Resolutions to Comments Discussed at Taipei Meeting

Summary of Comments from TG3c meeting

In this document we present the responses to open comments from TG3c meeting in Taiwan. This document will focus on comments except beamforming, stream index and preamble design, which will be finalized during Orlando meeting. We present 22 resolutions out of 33 technical comments and 4 out of 7 editorial comments. The summary of comments and our responses are given below. Resolutions related to PHY start from slide 3 and related to MAC from slide 21.

What agreed on Super-PNC in Atlanta Meeting

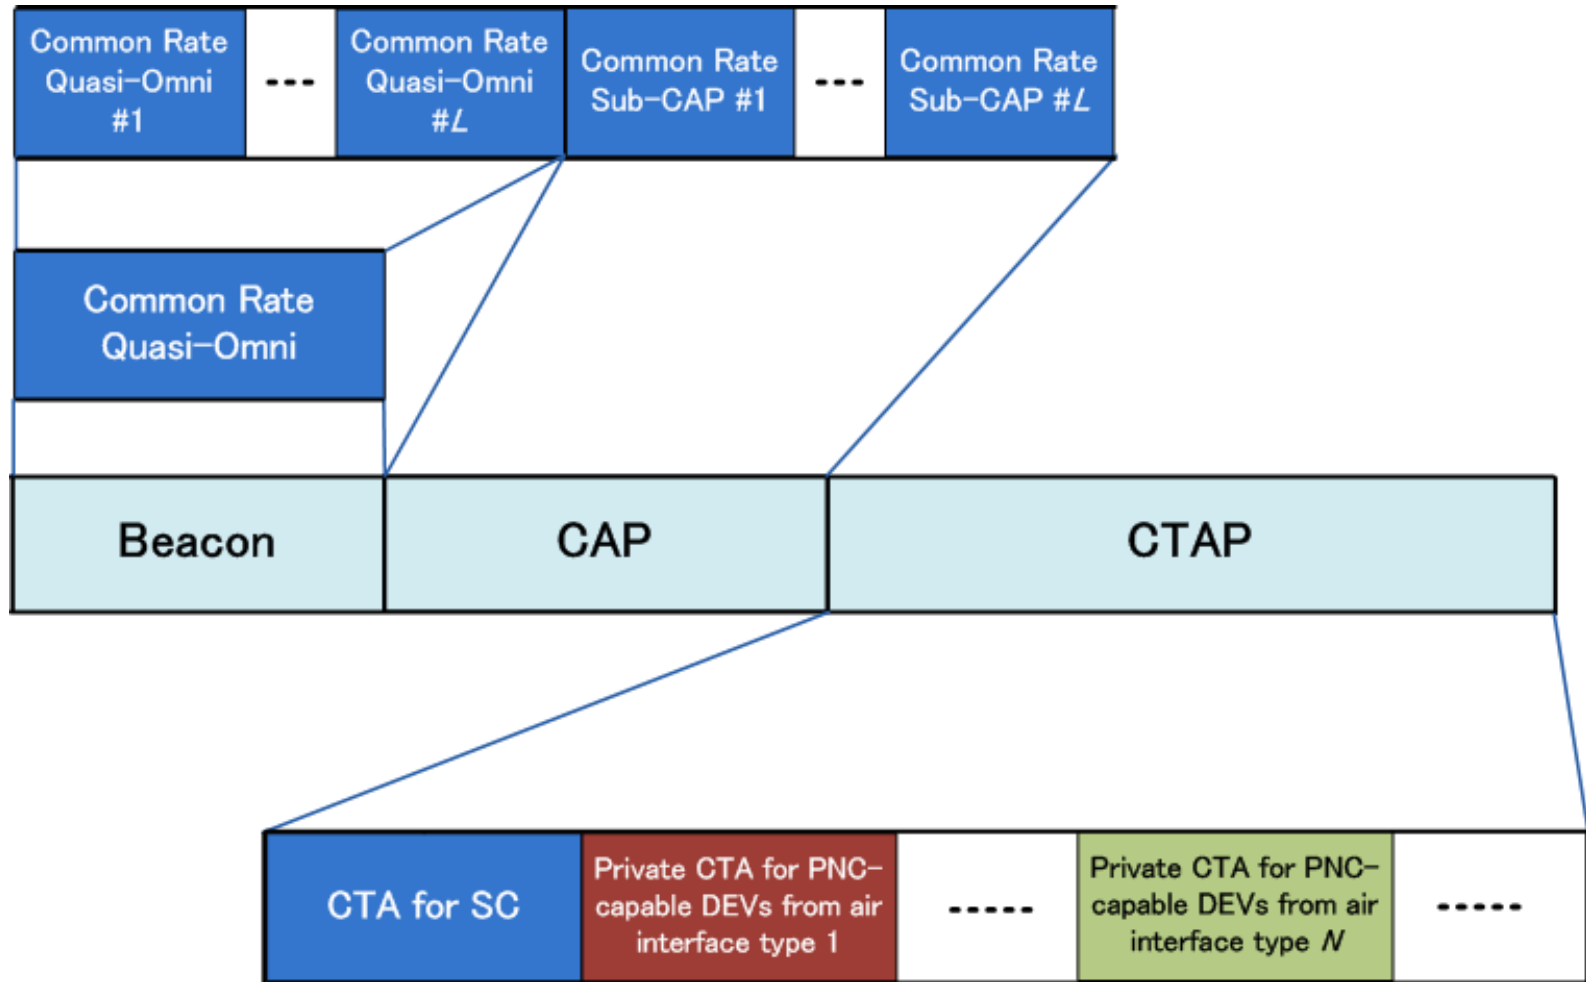
- Common Rate shall be mandatory for Super-PNC
- Common Rate is mandatory for SC DEVs and optional for OFDM DEVs
- A non-SC PNC-capable DEV **has to support Common Rate** if it wishes to communicate with Super-PNC

Throughput improvement from fine resolution (2/7)

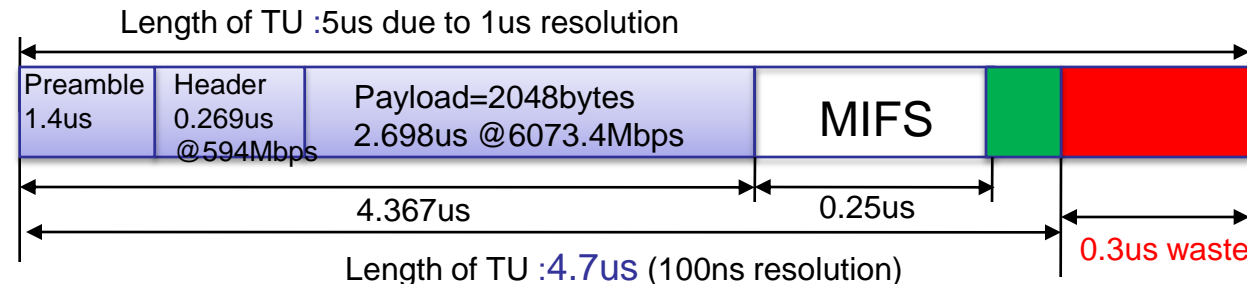
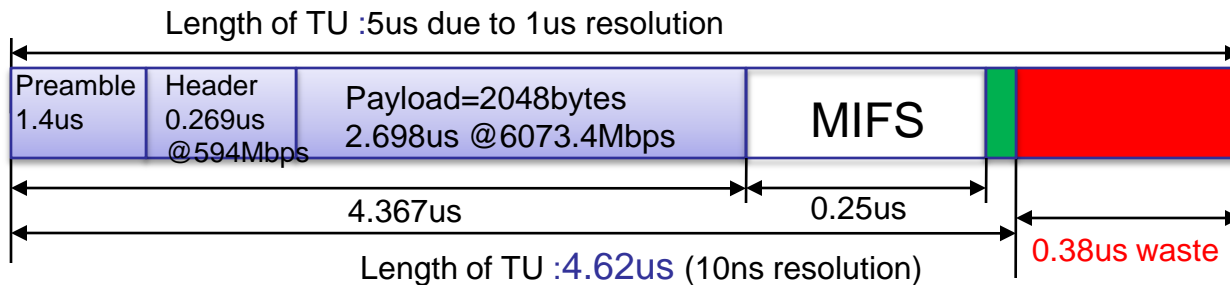
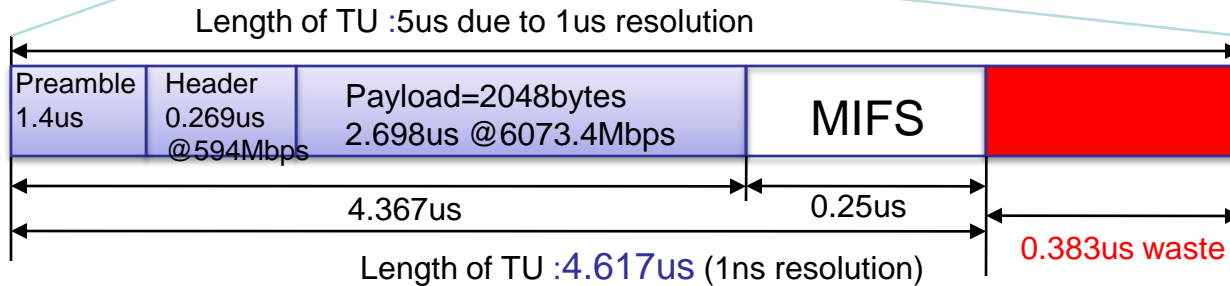
- Comment
 - Does the resolution of the superframe timing need to be less than 1 *us*?”
- Resolution
 - Yes. 1 us superframe resolution should be changed to 10 ns for the sake of up to 14 % throughput improvement with 2 Kbytes data transmission at 6Gbps PHY-SAP
 - The corresponding overhead in beacon is less than 1% against superframe length, which is ignorable

- Assuming 2Kbytes data frame transmission at 6Gbps, 7% of time for per frame transmission is wasted due to coarse resolution (1us)
- 14.2% throughput improvement can be achieved if resolution is changed to 1ns

- Percentage of time wasted per frame
 - $R1 = \text{Waste} / (T_{\text{Preamble}} + T_{\text{Header}} + T_{\text{Payload}} + \text{MIFS} + \text{Waste})$
- Throughput with coarse resolution
 - $S1 = \text{Payload} / (T_{\text{Preamble}} + T_{\text{Header}} + T_{\text{Payload}} + \text{MIFS} + \text{Waste})$
- Throughput with fine resolution
 - $S2 = (\text{Payload} + \text{Waste} * \text{dataRate}) / (T_{\text{Preamble}} + T_{\text{Header}} + T_{\text{Payload}} + \text{MIFS} + \text{Waste})$
- Percentage of throughput improvement
 - $R2 = (S2 - S1) / S1 = (\text{Waste} * \text{dataRate}) / \text{Payload} = \text{Waste} / T_{\text{payload}}$

Comment # 11

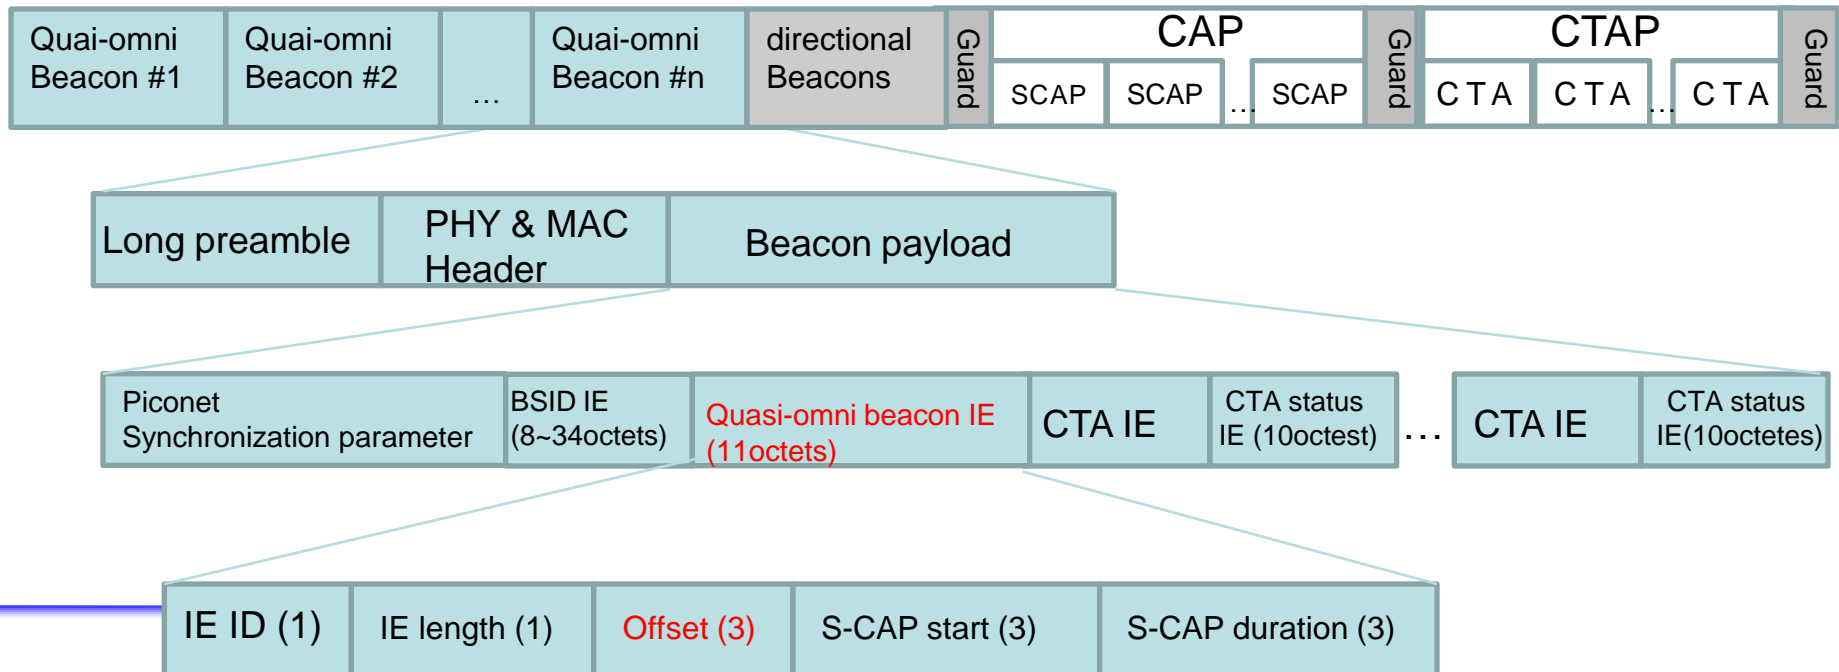
- Comment
 - How do DEVs know when the superframe starts and when the last beacon ends if they receive one beacon in the middle of a set of beacons.
- Resolution
 - Quasi-omni beacon IE is defined to indicate the offset from the start of the superframe to the first symbol of the current received beacon

Use 802.15.3 probe command for UEP information exchange

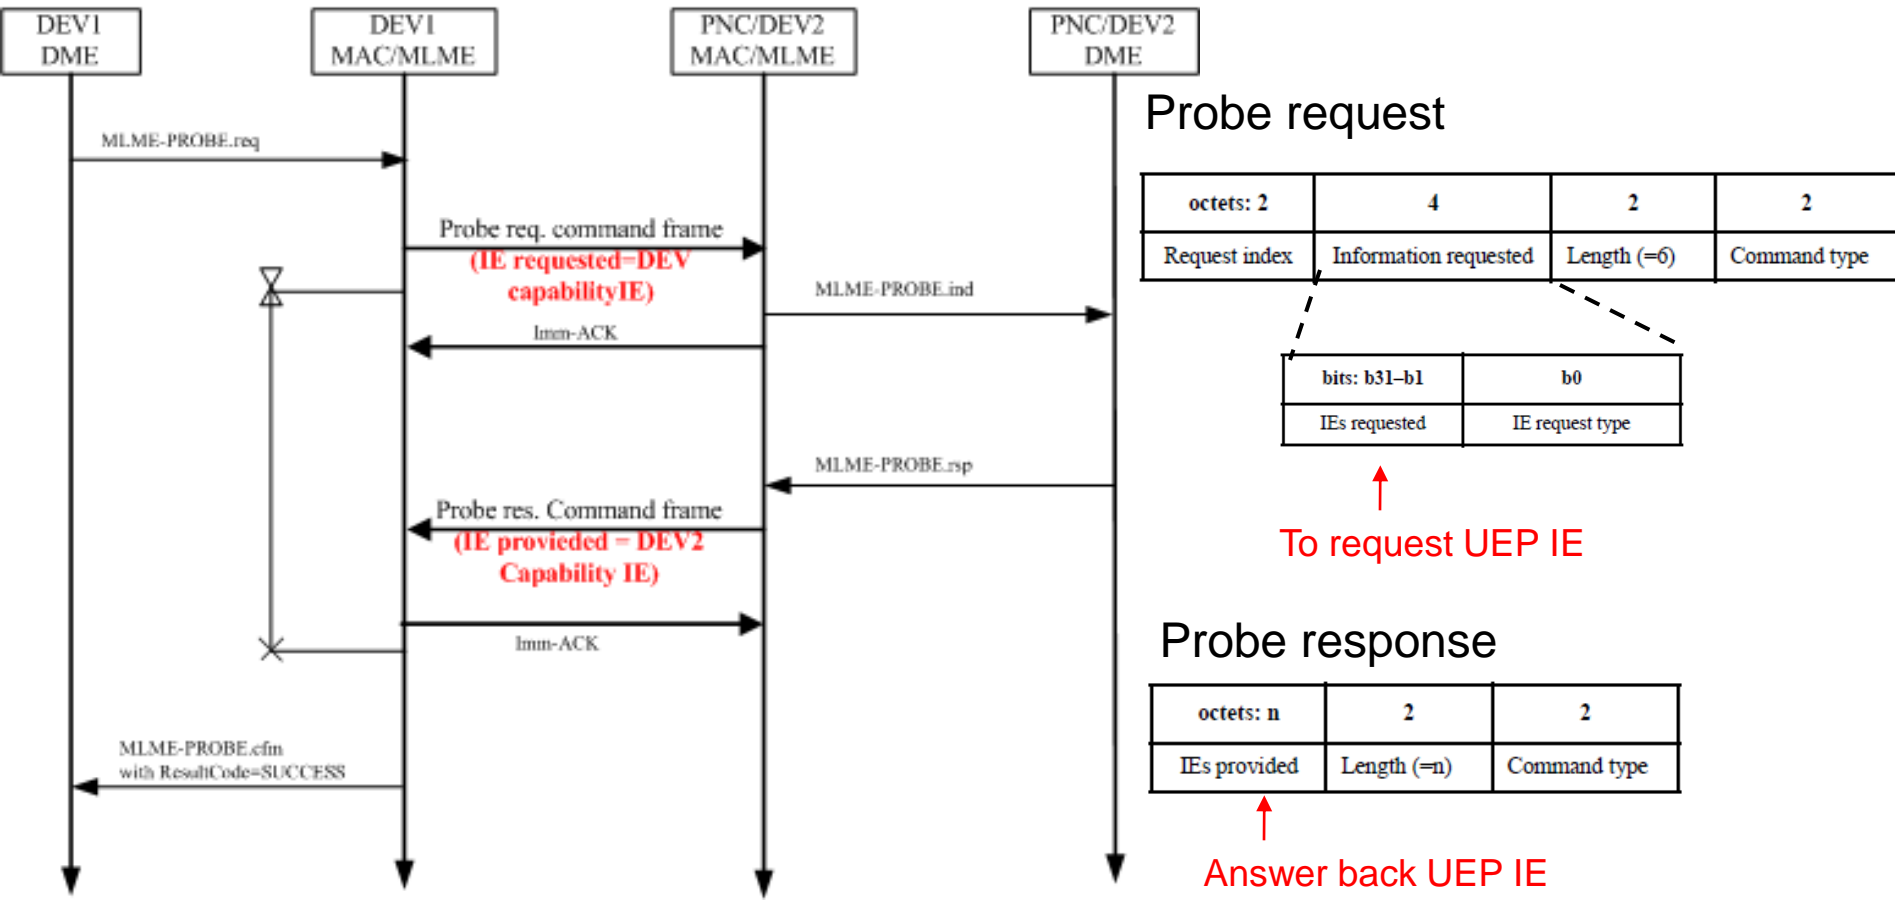
- Comment #17
 - Can this be done with an information element? Also, there are some updates to the frame format that need to be reviewed.
- Resolution
 - Yes, rather than creating new command frame, UEP (TBD) IE can be exchanged for the same purpose. This issue is related with Comment #36
- Comment #36
 - Rather than using commands, if the UEP capabilities are exchanged as part of the normal capabilities exchange, then the commands are not needed.
- Resolution
 - That is right. 802.15.3 already has the peer discovery function (use probe command) which can be used to exchange UEP information. What needed is just to exchange UEP (TBD) IE between DEVs which have intention of UEP streaming
